# City of Albertville Council Agenda

**SUBJECT: PLANNING – MEDART INDUSTRIAL DEVELOPMENT APPLICATIONS**

**PLANNING REPORT**

**LANDSCAPE PLAN**

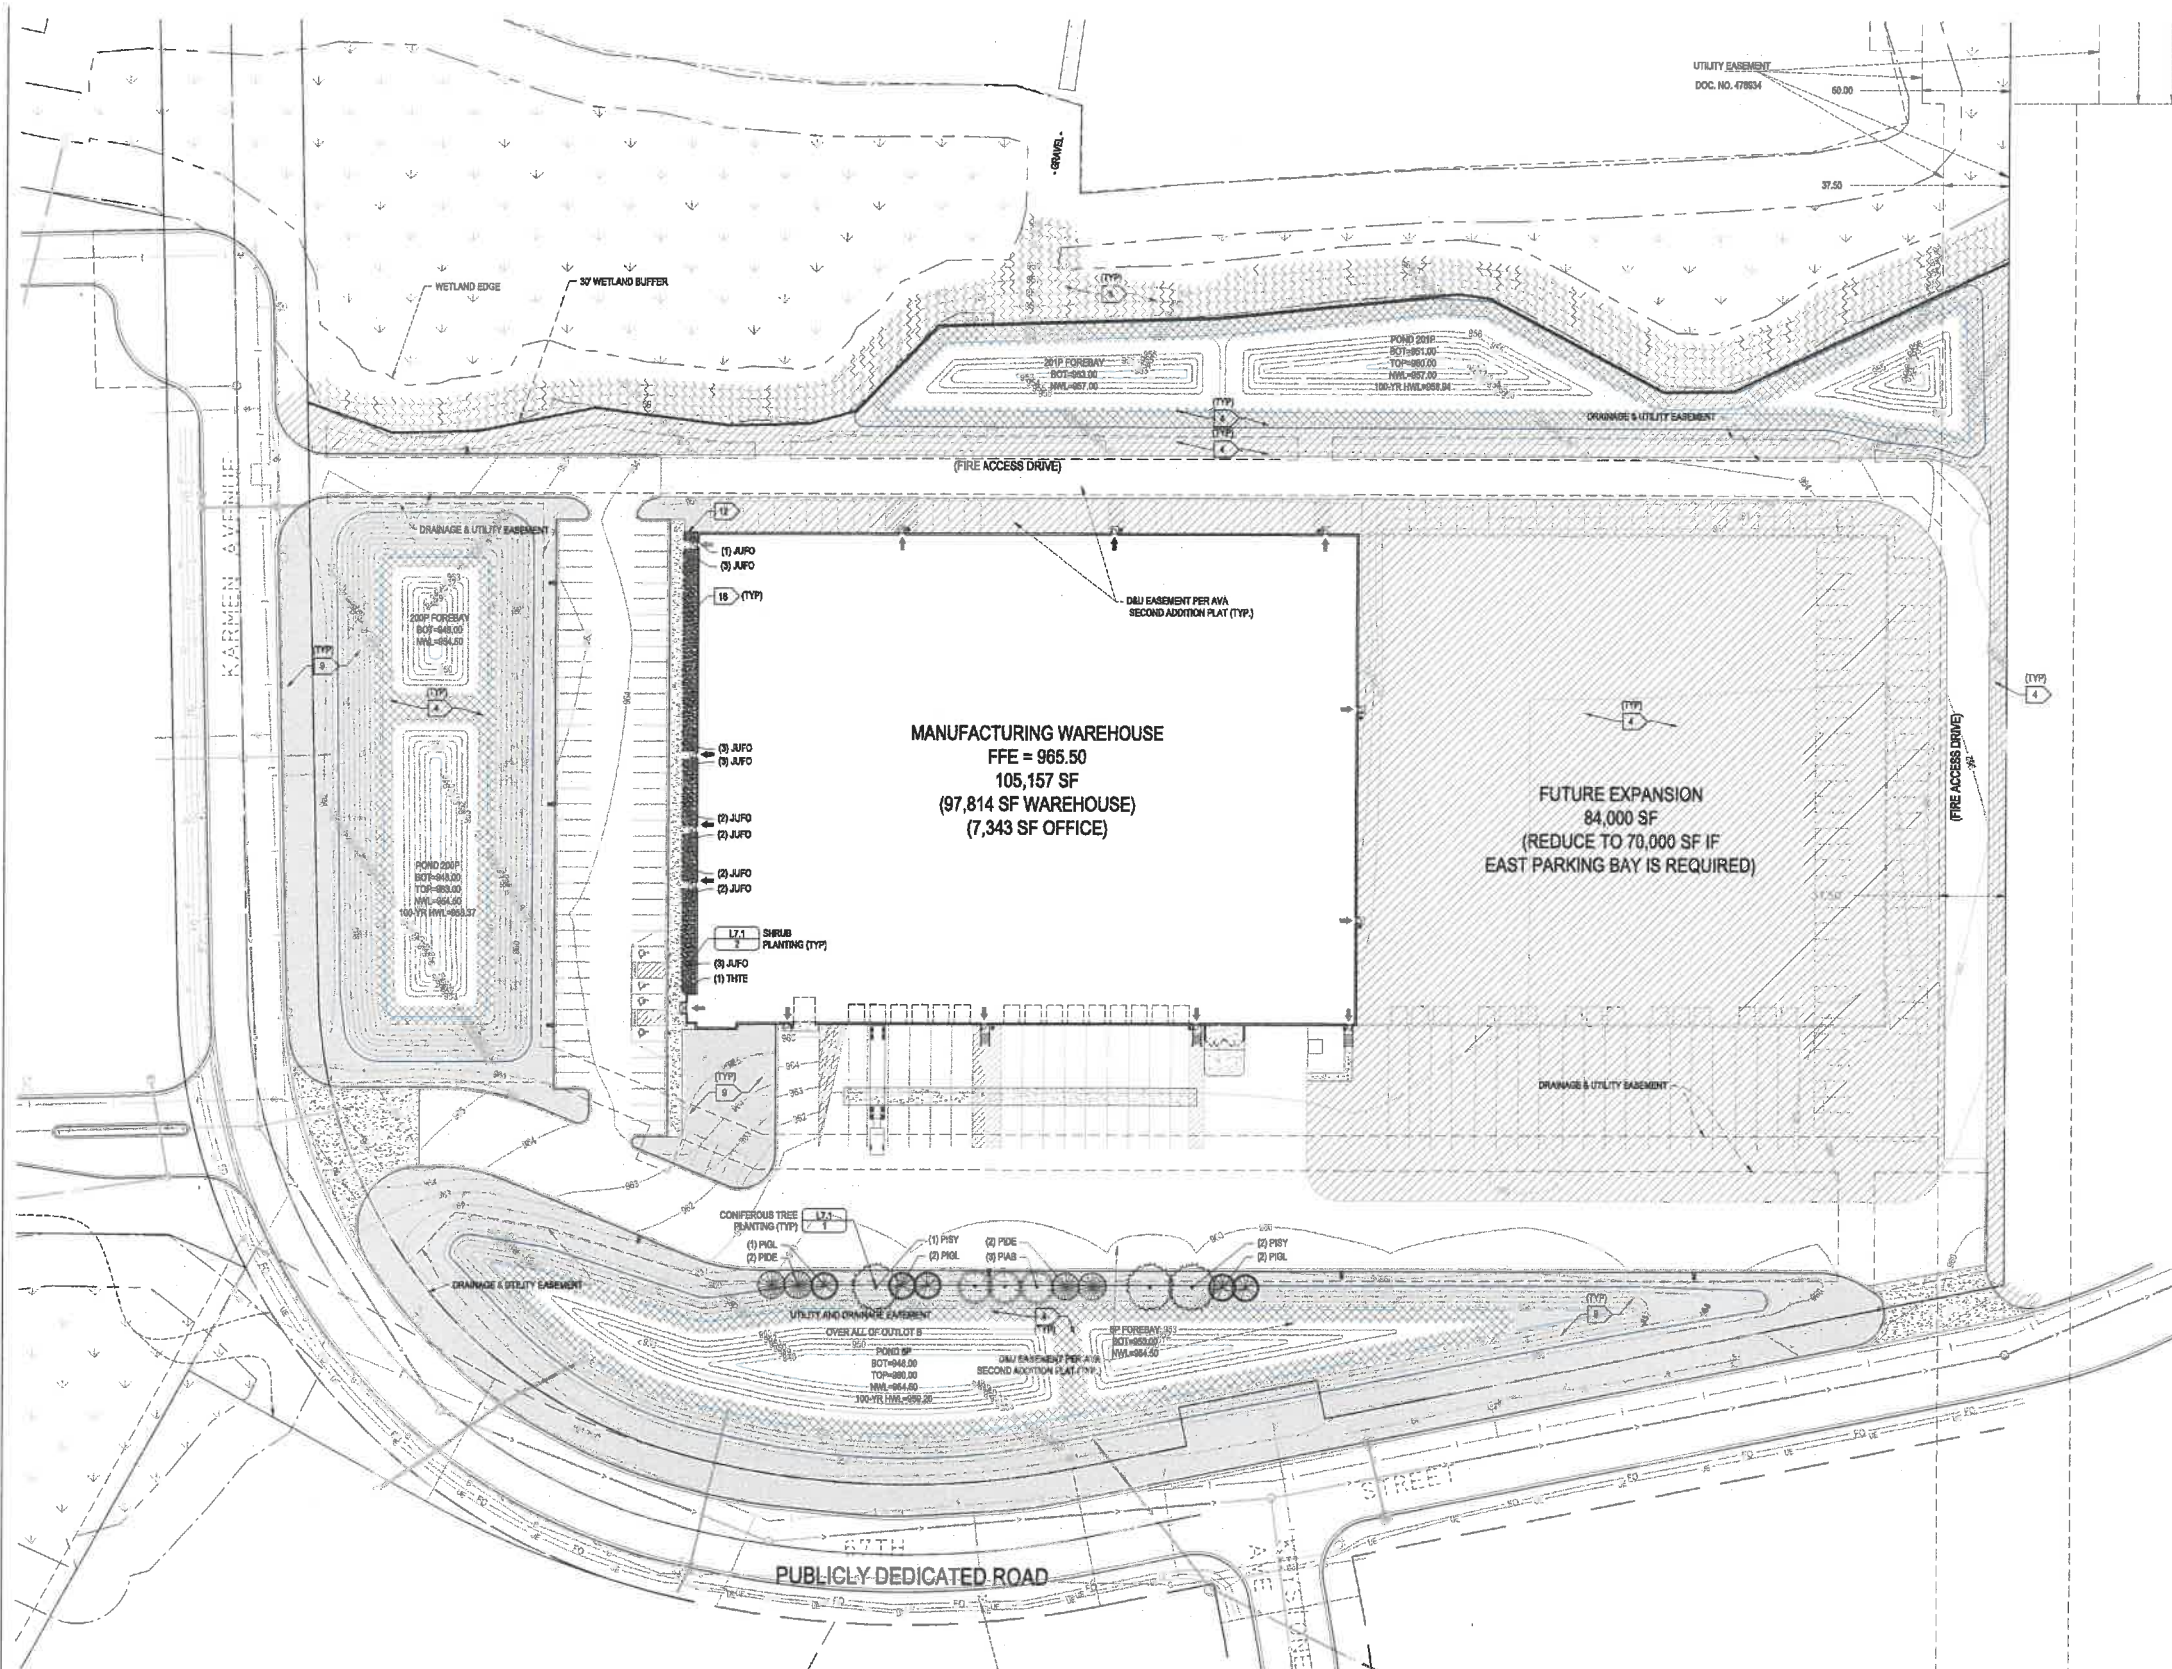
Landscaping. Section 1000. 7 outlines the landscaping and screening required for commercial and industrial lots. The landscaping plan that has been submitted. In review of the landscape plan, we offer comments.

1. The site plan does a good job reestablishing ground cover over the areas disturbed by grading with sod and seed mixes that are appropriate for their areas of use.

2. The southern loading area is required to be screened from 67<sup>th</sup> Street. The landscape plan proposes single row plantings along the south curb line of the loading area. The trees consist of 8 foot tall coniferous trees. The base of the loading berths at the building is at a 961.5 elevation. The proposed trees are being planted at a 959 elevation. In this arrangement, the trees will not provide effective screening at time of installation. Staff recommends that the plan be revised to include the following.

- b. The landscape screen shall be extended for the full length of the initial construction and the proposed future addition, to allow the plantings to grow and mature together, becoming a more effective screen over time.

- c. A landscape screen or screen wall shall be provided within the green space along the west end of the loading berths.
3. The zoning code requires screening at that periphery of the parking lot from the public street. The landscape plan must provide screening either landscaping or fence along the western edge of the west parking lot. Said screen shall be of a height to screen headlights directed toward the public street.
4. The plantings along the west side of the building meet the City requirements of the zoning code.
5. The site and landscape plan must illustrate landings and clear paths from the doors on the north and east sides of the building to a drive aisle. These landings and clear paths shall be kept clear of obstructions and snow year-round.

8. The landscape plan shall be revised to include the following.
  - The landscape screening shall consist of a double stagger row of coniferous trees. Trees shall be a minimum of 8 feet in height. The spacing of trees in the same row shall be no greater than ten feet on center.

- The landscape screen shall be extended for the full length of the initial construction and the proposed future addition, to allow the plantings to grow and mature together, becoming a more effective screen over time.

- A landscape screen or screen wall shall be provided within the green space along the west end of the loading berths.
  - The landscape plan must provide screening either landscaping or fence along the western edge of the west parking lot. Said screen shall be of a height to screen headlights directed toward the public street.
9. The lighting plan be revised to include one additional wall mounted light over the man door at the northwest corner of the building.
  10. A separate sign permit shall be required with the submission of the building permit showing wall signs, freestanding signs and any on-site directional or traffic control signs.
  11. Grading, drainage, and utilities plans shall be subject to final review and approval by the City Engineer.
  12. The Applicant shall enter into a PUD/Development agreement outlining the terms of site development and conditions of PUD approval.
